Designation: ~~C230/C230M-03~~ Designation: **C 230/C 230M – 08**

Standard Specification for Flow Table for Use in Tests of Hydraulic Cement¹

FIG. 1 Flow Table and Accessory Apparatus (Partial) (In./Lb)

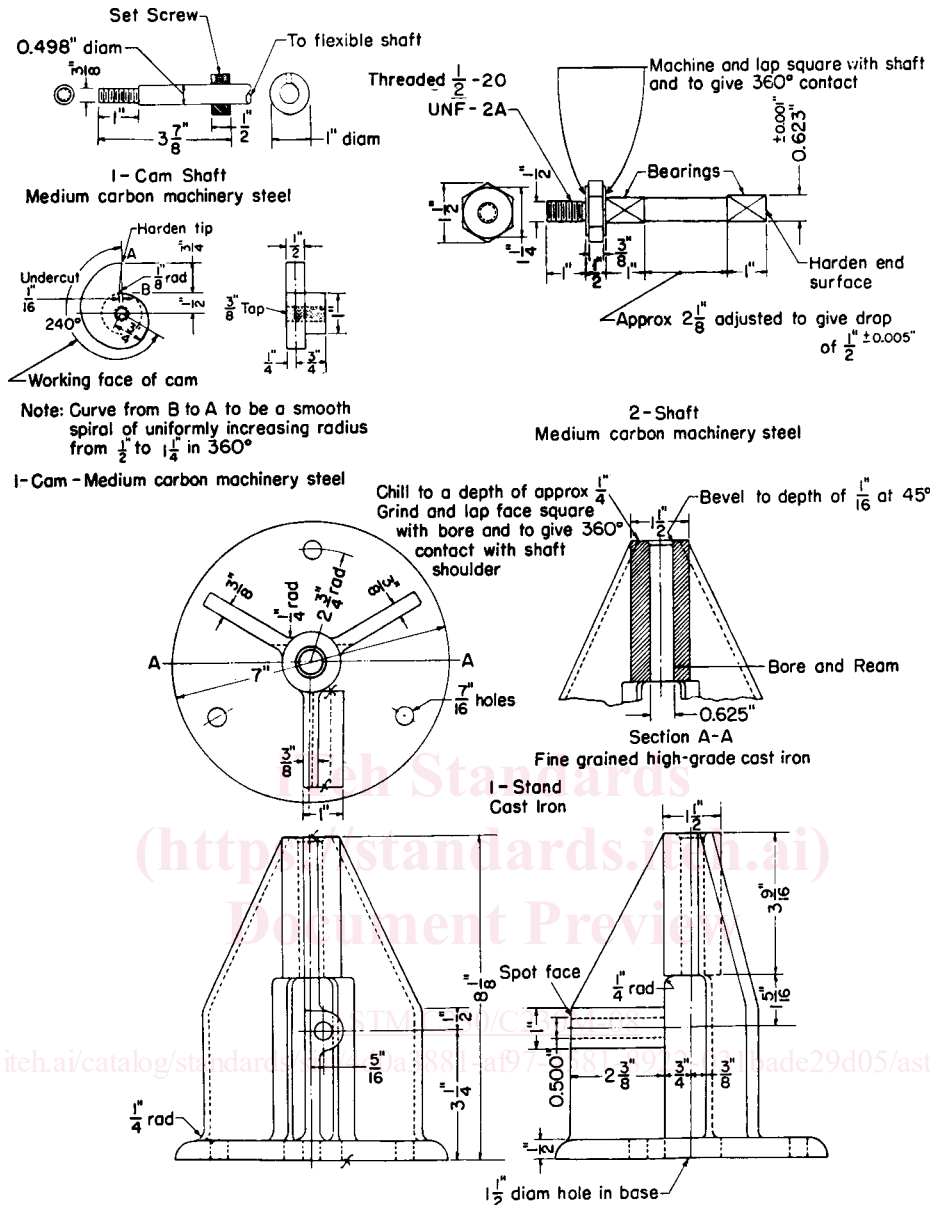
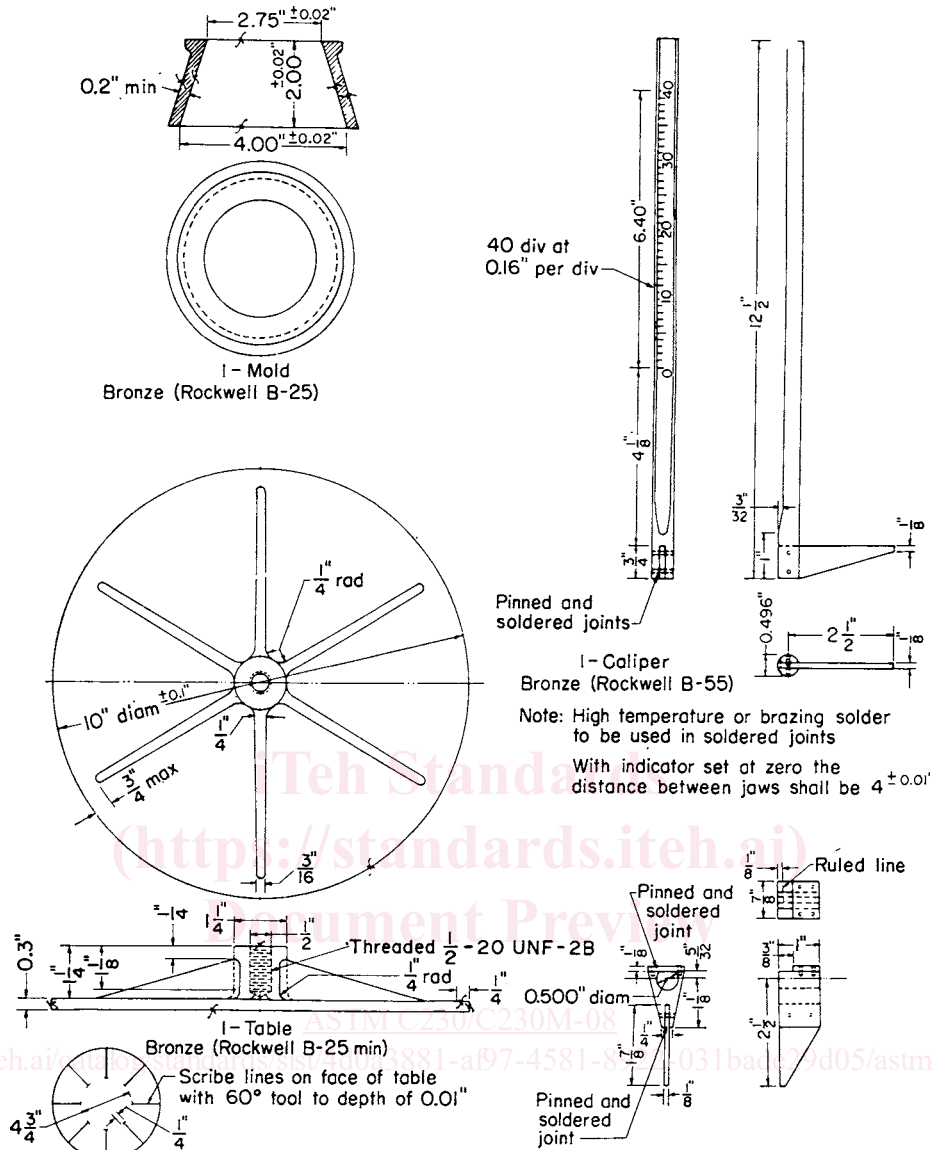
NOTE 1—To help clarify the design of the flow table and accessory apparatus see the drawing in Fig. 1 [Fig. 2]. This drawing is for informational purposes only.

~~3.1~~ 3.1 The flow table apparatus shall consist of an integrally cast rigid iron frame and a circular rigid table top 10 ± 0.1 in. [255 ± 2.5 mm] in diameter, with a shaft attached perpendicular to the table top by means of a screw thread. The table top and shaft with contact shoulder shall be mounted on a frame in such a manner that it can be raised and dropped vertically through the specified height of 0.500 ± 0.005 in. [12.7 ± 0.13 mm] for new tables and of 0.500 ± 0.015 in. [12.7 ± 0.38 mm] for tables in use, by means of a rotated cam. The table top shall have a fine machined plane surface, free of blowholes and surface defects. The top shall be scribed with eight equidistant lines $2\frac{5}{8}$ in. [68 mm] long, extending from the outside circumference toward the center of the table. Each line shall end with a scribed arc, $\frac{1}{4}$ in. [6 mm] long, whose center point is the center of the table top with a radius of $2\frac{3}{8}$ in. [59.5 mm]. The scribe lines shall be made with a 60° tool to a depth of 0.01 in. [0.25 mm]. The table top shall be of cast brass or bronze having a Rockwell hardness number not less than 25 HRB with an edge thickness of 0.3 in. [7.5 mm], and shall have six integral radial stiffening ribs. The table top and attached shaft shall weigh 9 ± 0.1 lb [4.08 ± 0.05 kg] and the weight shall be symmetrical around the center of the shaft.

~~3.2~~ 3.2 The cam and vertical shaft shall be of medium carbon machinery steel, hardened on the end of the shaft contacting the cam and the tip of the cam contacting the shaft. The shaft shall be straight and the difference between the diameter of the shaft and the diameter of the bore of the frame shall be not less than 0.002 in. [0.05 mm] and not more than 0.003 in. [0.08 mm] for

new tables and shall be maintained at 0.002 to 0.010 in. [0.05 to 0.25 mm] for tables in use. The end of the shaft shall not fall upon the cam at the end of the drop, but shall make contact with the cam not less than 120° from the point of drop. The face of the cam shall be a smooth spiraled curve of uniformly increasing radius from 1/2 to 1 1/4 in. [13 to 32 mm] in 360° and there shall be no appreciable jar as the shaft comes into contact with the cam. The cam shall be so located and the contact faces of the cam and shaft shall be such that the table does not rotate more than one revolution in 25 drops. The surfaces of the frame and of the table that come into contact at the end of the drop shall be maintained smooth, plane, and horizontal and parallel with the upper surface of the table and shall make continuous contact over a full 360°.

2.3The3.3 The supporting frame of the flow table shall be integrally cast of fine-grained, high-grade cast iron. The frame casting shall have three integral stiffening ribs extending the full height of the frame and located 120° apart. The top of the frame shall be chilled to a depth of approximately 1/4 in. [6 mm], and the face shall be ground and lapped square with the bore to give 360° contact with the shaft shoulder. The underside of the base of the frame shall be ground to secure a complete contact with the steel plate beneath.

2.4The3.4 The flow table shall be driven by a motor (Note 2), connected to the cam shaft through an enclosed worm gear speed reducer and flexible coupling. The speed of the cam shaft shall be approximately 100 r/min. The motor drive mechanism shall not be fastened or mounted on the table base plate or frame.
